**REPORT TO GEORGES RIVER COUNCIL  
LPP MEETING OF THURSDAY, 15 JULY 2021**

| <b>LPP Report No</b>   | <b>LPP029-21</b>   | <b>Development Application No</b> | <b>DA2021/0078</b> |
| <b>Site Address &amp; Ward Locality</b>  | 165 Penshurst Street Beverly Hills<br>Mortdale Ward  |                                   |                    |
| <b>Proposed Development</b>  | Alterations and additions to an industrial building and use of the premises as a self-storage facility   |                                   |                    |

Figure 1: Proposed site plan

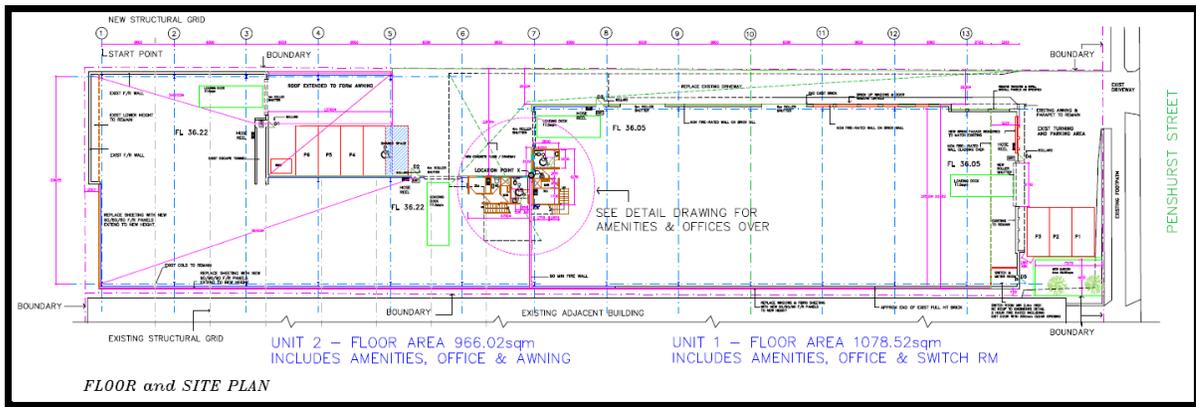
| <p><u>Discussion on car parking</u><br/>In accordance with the Hurstville DCP No. 1, the use (warehouse) requires parking to be provided at a rate of 1 space per 300sqm floor area, which equates to 7 spaces for the proposal. The plans indicate 3 spaces at the front of the site and 4 spaces at the rear of the site.</p> <p>However the SEE submitted with the DA states “there is some space at the rear of the site which, although used and intended to be used for the most part as a loading zone, is used from time to time as space for informal parking....formal provision for onsite car parking is proposed at the front of the site in the form of car spaces for visitors and workers.”</p> <p>The parking at the rear of the site contains the only accessible parking space on the site. Relocation of that space to the front parking area would reduce the parking to two spaces.</p> <p>The formal parking provided on site is insufficient for the proposed use and this forms one of the reasons for refusal of the application.</p> |  |  |   |

137. The proposed landscaped area (29sqm or 1% of the site area) in the front setback does not meet the minimum DCP requirements for 10% landscaped area or a 3m wide strip (and no parking in the front setback). No Landscape Plan was submitted with the DA.

Figure 9: 9am Winter shadow analysis

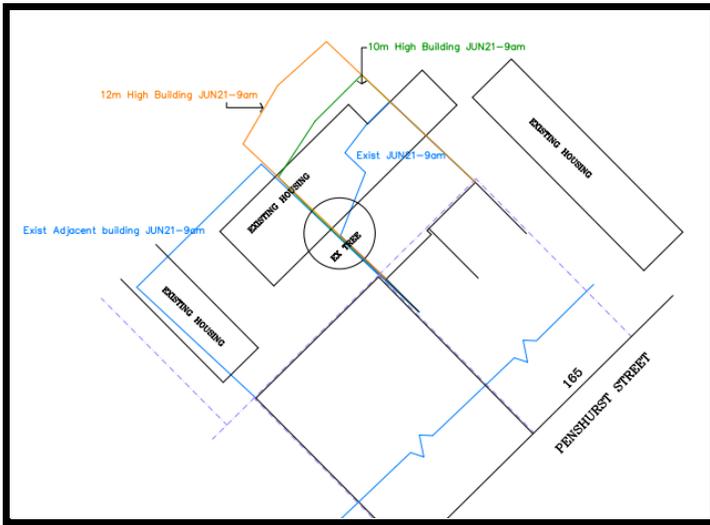
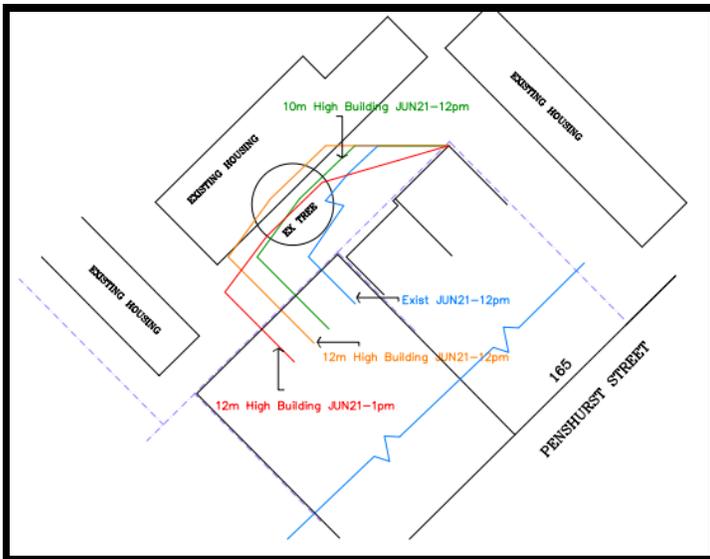
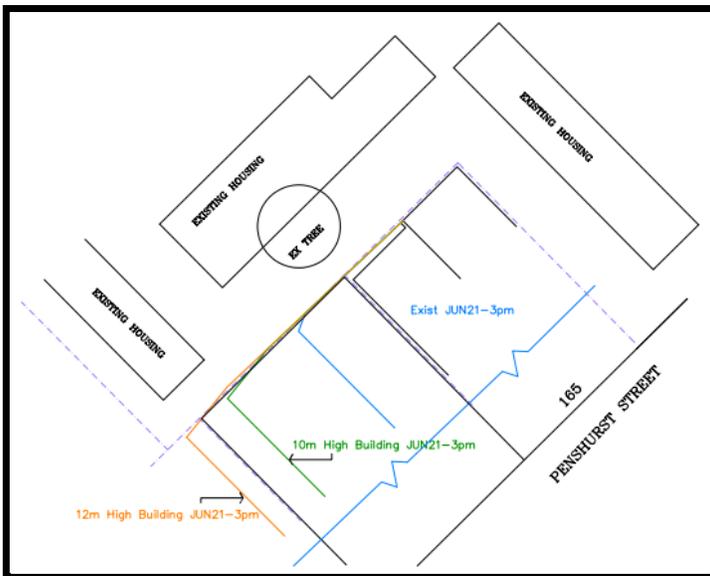
- The shadow diagrams provided to support the claim that there is no adverse impact on the solar access on neighbours are, at best, basic, and offer very little in the way of assessing the impact on neighbouring residential properties:

94. Minor additional shadowing of neighbouring properties (based on very limited physical evidence by way of architectural drawings) is an outcome of the proposal but not a justification for the breach and is not a sufficient environmental planning ground.
